CMB Special Meeting Minutes #162

SUBJECT: Configuration Management Board Special Meeting # 162– Rev. No. 0

Request for Information #: **CTS-0064.0001**
SFMTA 3rd St Light Rail Prog

Project: Central Subway Stations, Surface Track & Systems
Subject: FH conflict at Washington e/o Stockton, Sta. 11+76
Requested By: Marcus Gomez
Specs/Drwg Reference: AWSS 201.6
Date Reply Requested: ASAP

1424J-CHINATOWN
RFI NO. 205.2
MBS 03/19/14
SFDPR/IDC/EME

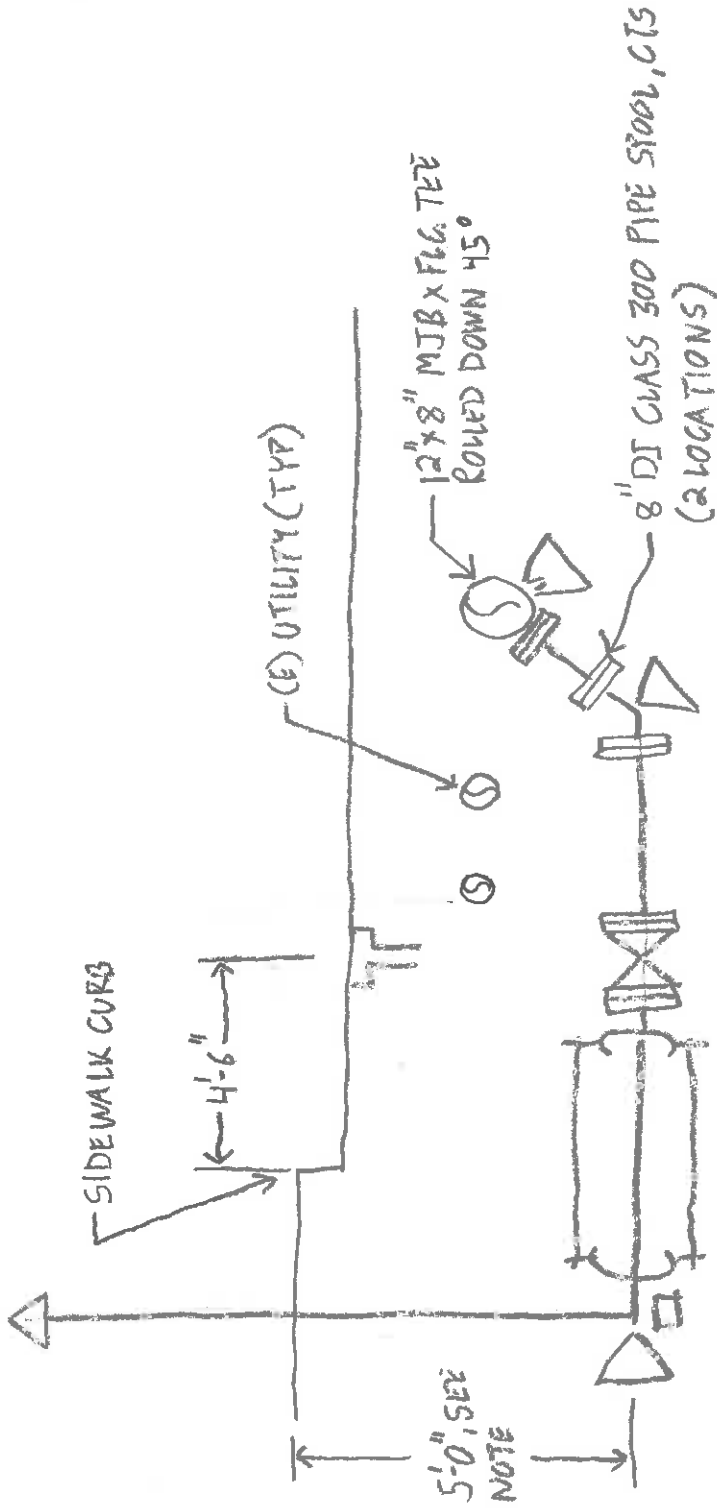
Submitted To:	Submitted By:
SF Municipal Transportation Agency Richard Redmond 821 Howard Street 2nd Floor San Francisco, CA 94103	Valverde Construction, Inc. Marcus Gomez 10918 Shoemaker Ave Santa Fe Springs, CA 90670
Subject	
Fire Hydrant conflict at Washington	
Copies To:	
Drawing Reference	
Information Requested	
Can we be provided with a response to Valverde's attached RFI No 17.1 forthwith? Please advise.	
Suggestion	
Response	
- IDENTIFY OWNER OF 3" Ø STEEL LINE AND SUPPORT LINE AS REQUIRED. - SEE ATTACHED SKETCH FOR HYDRANT LATERAL LAYOUT BASED ON THE INFORMATION PROVIDED. INSTALL AT STATION 11+76.

- HYDRANT HEIGHT/SETBACK ON SIDEWALK SHALL COMPLY WITH AWS STANDARD DRAWINGS. USE HYDRANT RISERS WHERE REQUIRED
- MAINTAIN 12" CLEARANCE BETWEEN (E) UTILITIES AND AWS FACILITIES.

ELEVATION
(LOOKING WEST)

WEST WASHINGTON & STOCKTON - CTS STA 11+76
 INFORMATION FOR HYDRANT OFF SET
 FORCE ACCOUNT # FA 010, ON WASHINGTON

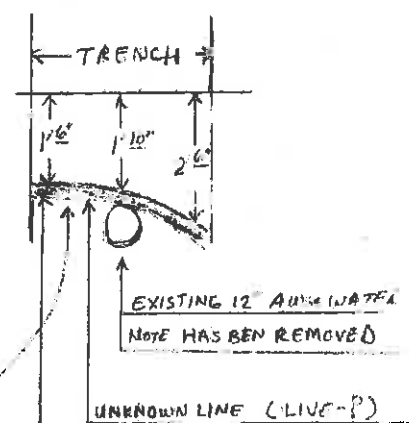
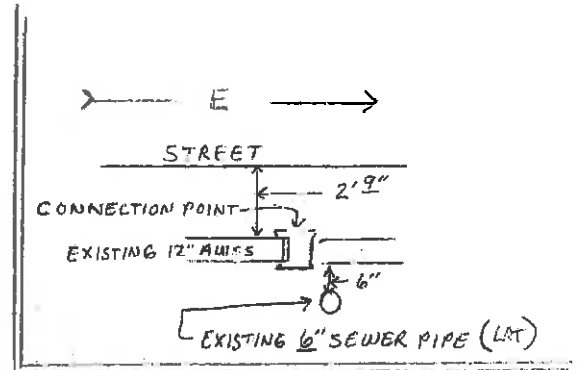
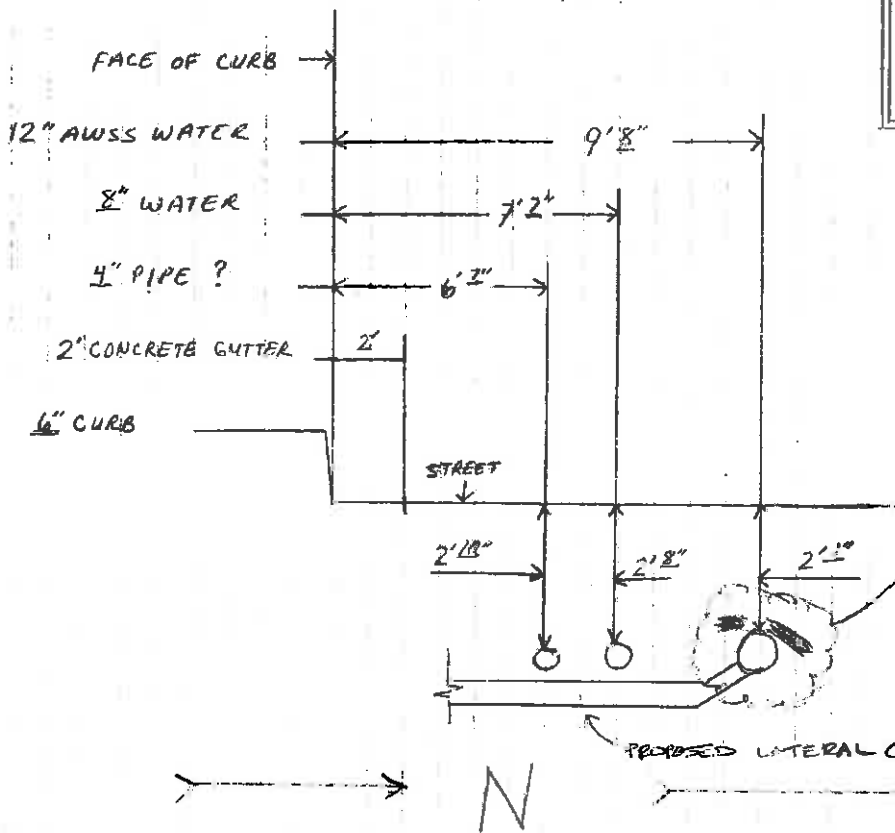
Per FACO 10 and RFI 160.1, the revised hydrant lateral was excavated and the proposed lateral was confirmed to be in conflict with an existing 4" & 8" utility. At the proposed tee location, an existing 3" steel line was found in conflict with the proposed top of tee.

Please provide direction on how to temporarily move the steel line and how to configure the proposed tee and hydrant lateral assembly. Please keep in mind the lead times for any additional AWSS material not shown on the contract drawings.

Attached is a sketch and photos of the existing conditions.

NOTE: STEEL PIPE NEEDS TO BE
 RAISED IN ORDER TO PUT ON HYDRANT
 TEE & WELD STOPS (3" STEEL ST LYE)
